Recall Bulletin

SB-10056213-4187

PRODUCT EMISSION RECALL

SUBJECT: Oxygen Sensor Fracture

(A) First Design Heated Oxygen Sensor (B) Second Design Heated Oxygen Sensor (1) Location of Part Number

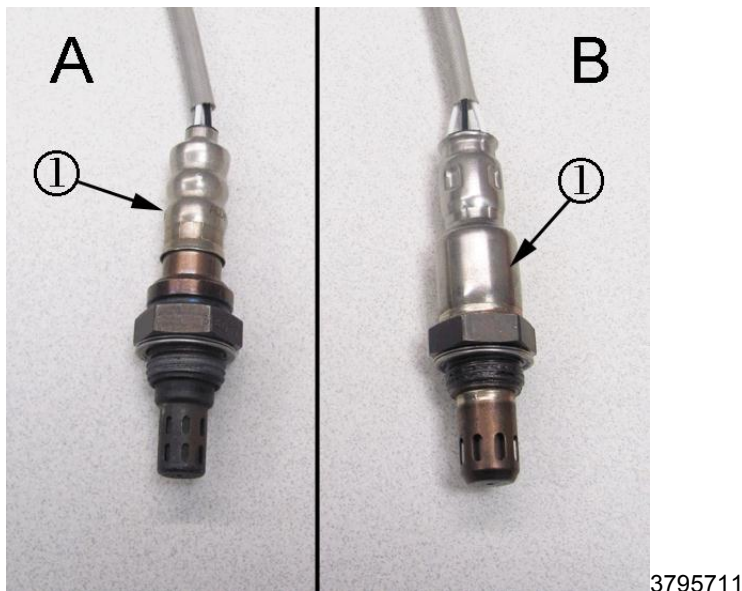
3. Determine if a first design (A) or second design (B) heated oxygen sensor is installed using a light and mirror.
 - If a second design (B), P/N 12637297, heated oxygen sensor is installed, no further action is required. Lower the vehicle. Refer to *Lifting and Jacking the Vehicle* in SI.
 - If a first design (A), P/N 12656071 or P/N 12612571, heated oxygen sensor is installed, remove the sensor and replace it with a second design heated oxygen sensor. Refer to *Heated Oxygen Sensor Replacement –Bank 2 Sensor 1* in SI and *Heated Oxygen Sensor Replacement –Bank 2 Sensor 2* in SI.
